Engineering Operations
Building Addition

Contract: 6484
Project: 10308
Common Council Approval:
8/2/2015

Revisions by Addendum

No.	Description	Addendum
1	Re-issued and added notes for clarification	1

Garage Piping

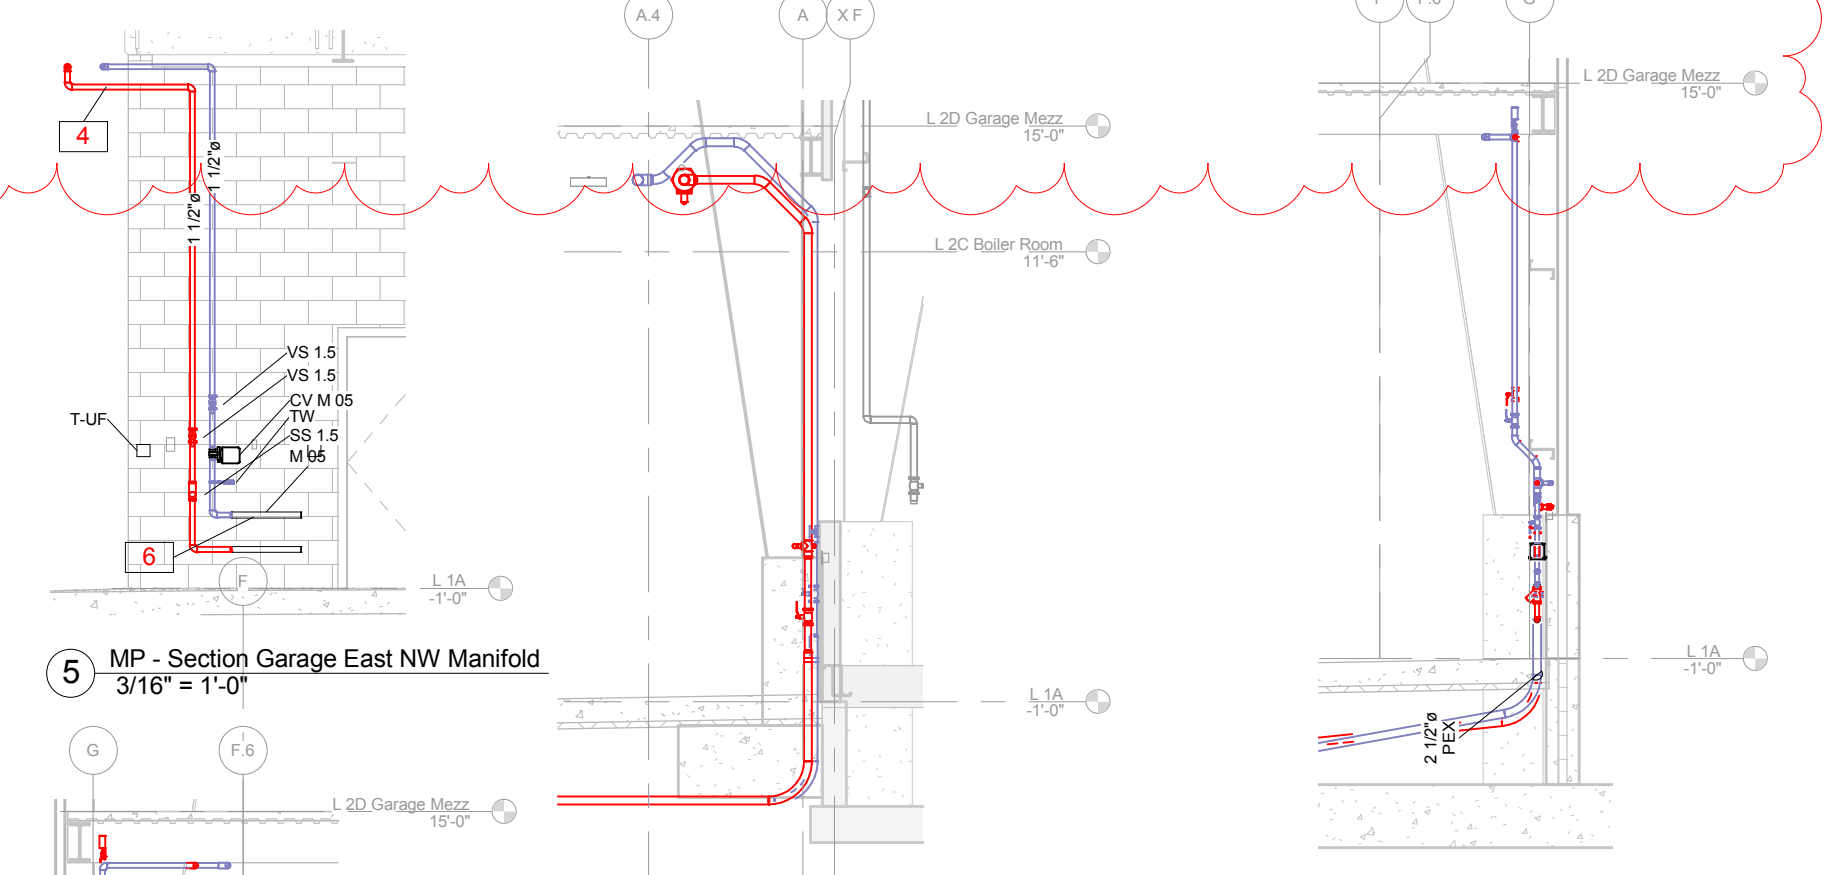
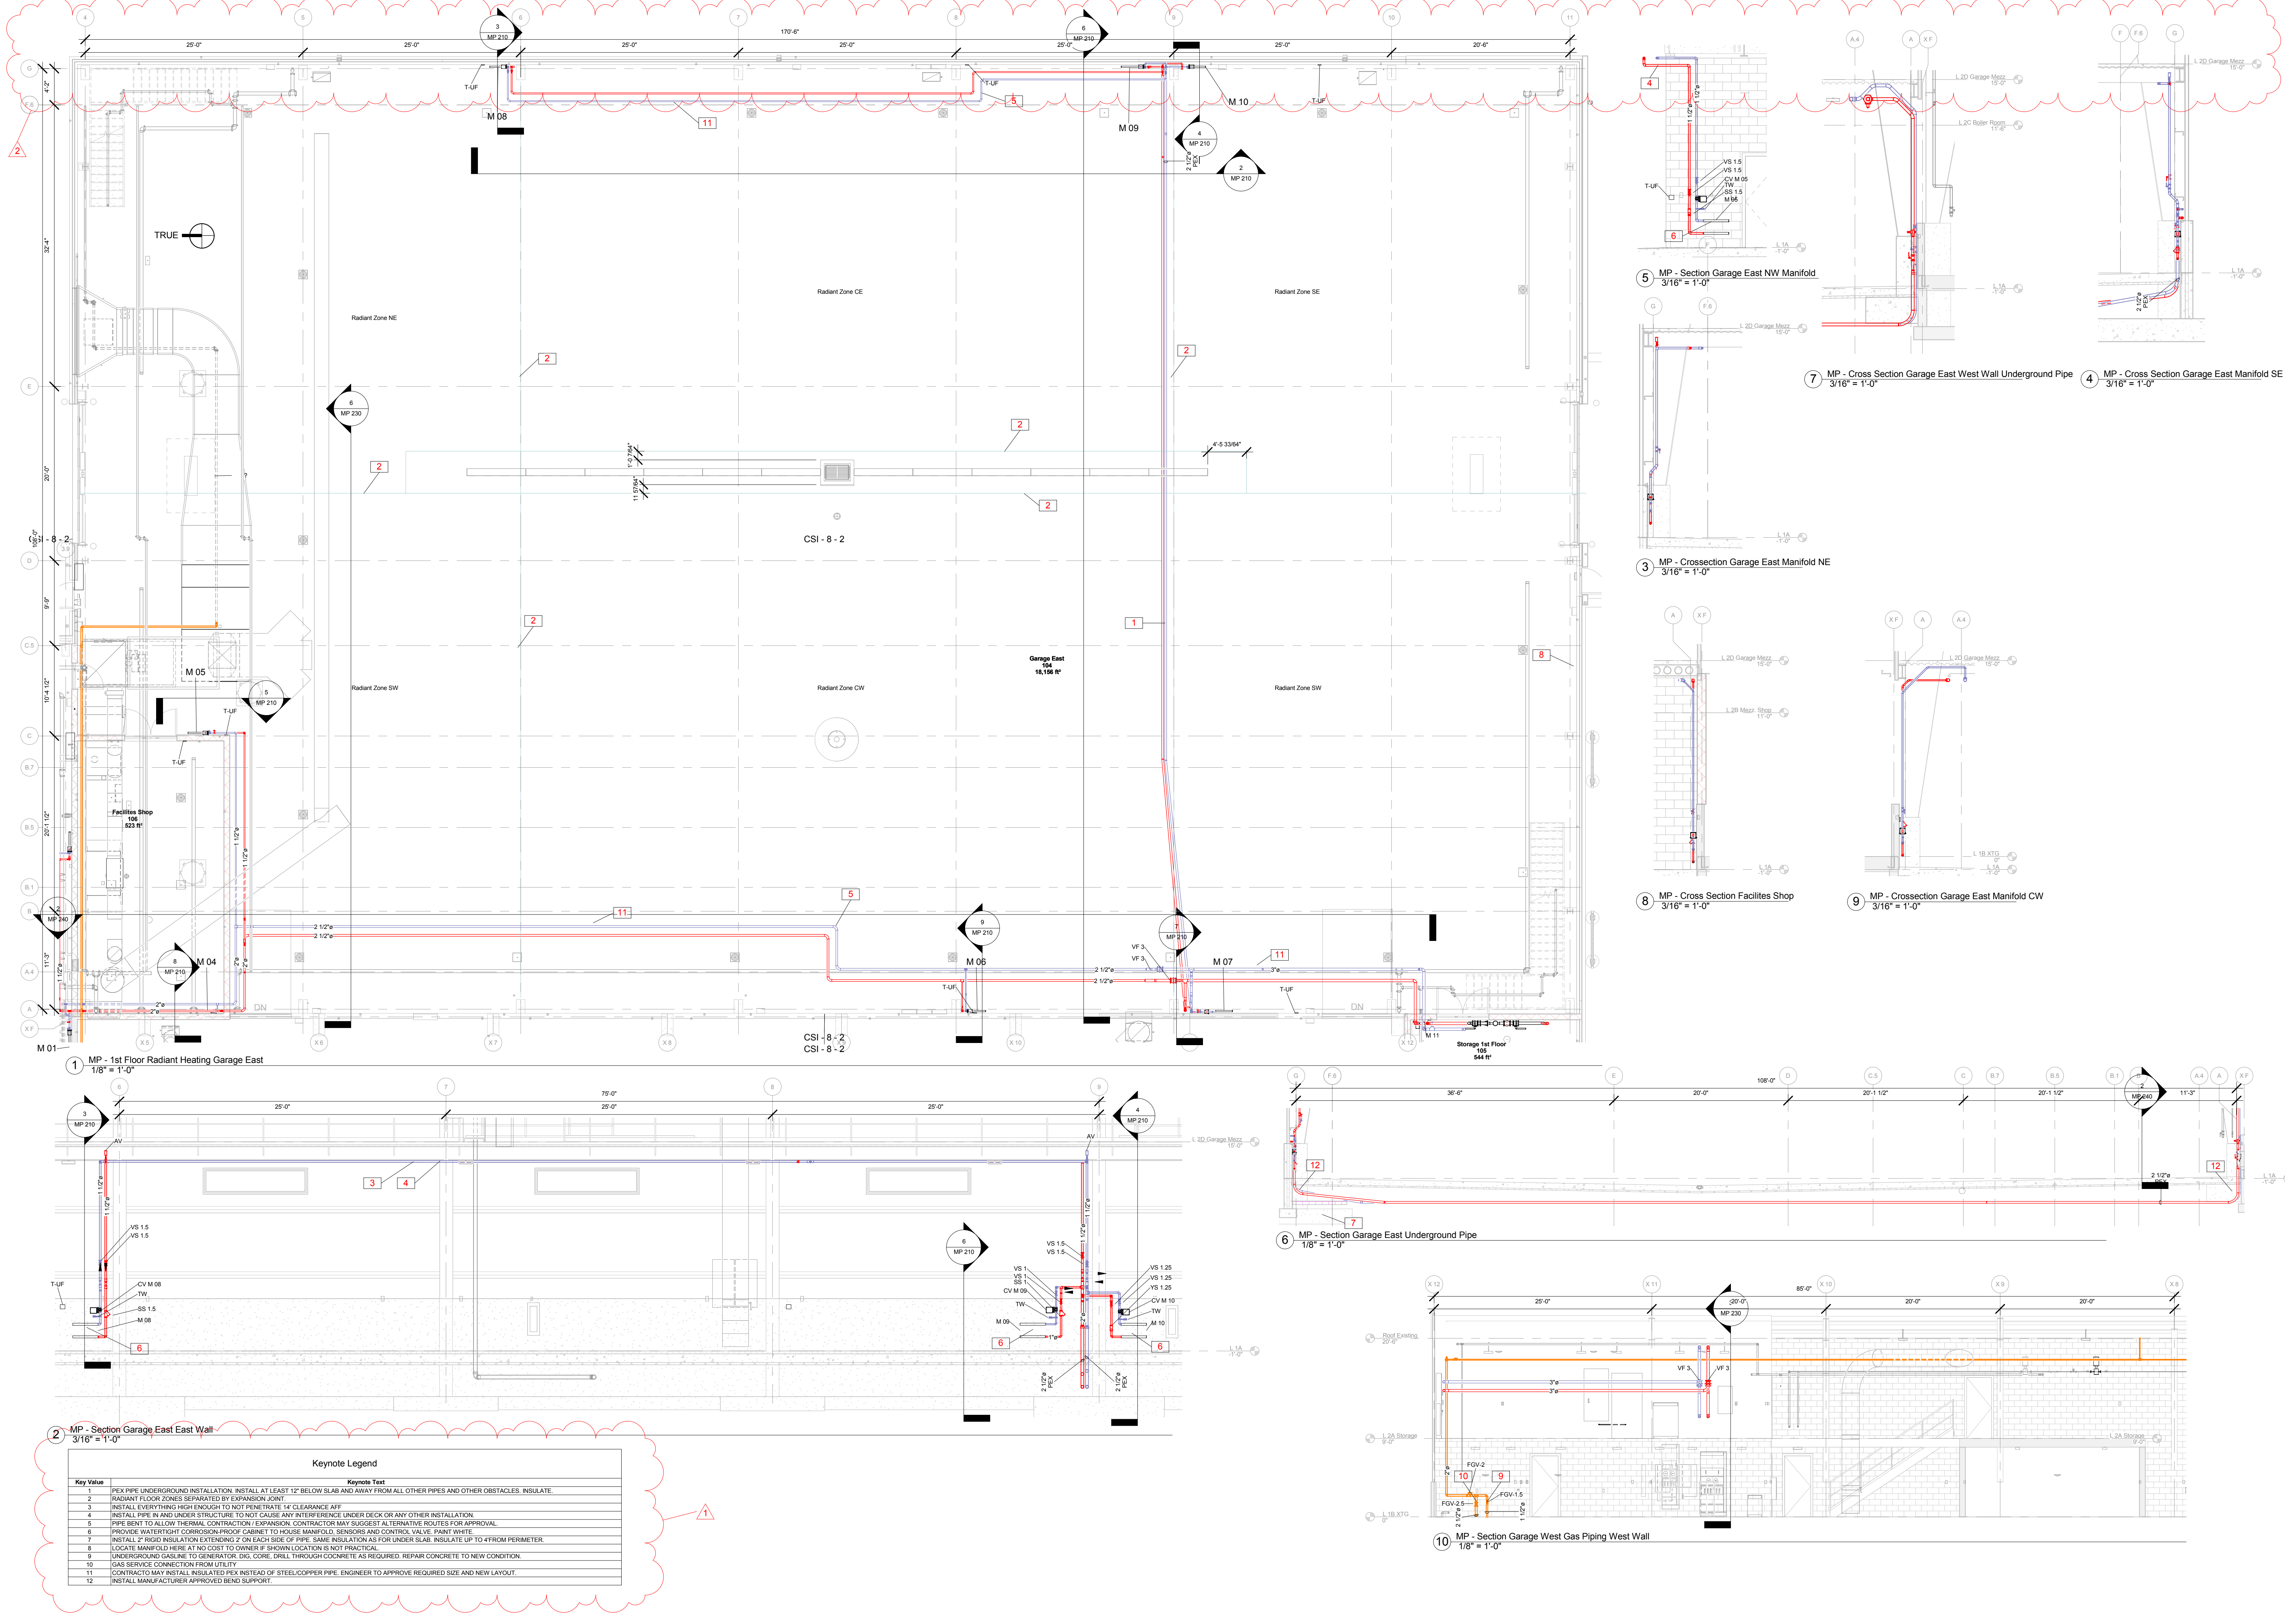
No.	Description	Addendum
1	Reformatted schedule	1
2	Relocated view	1
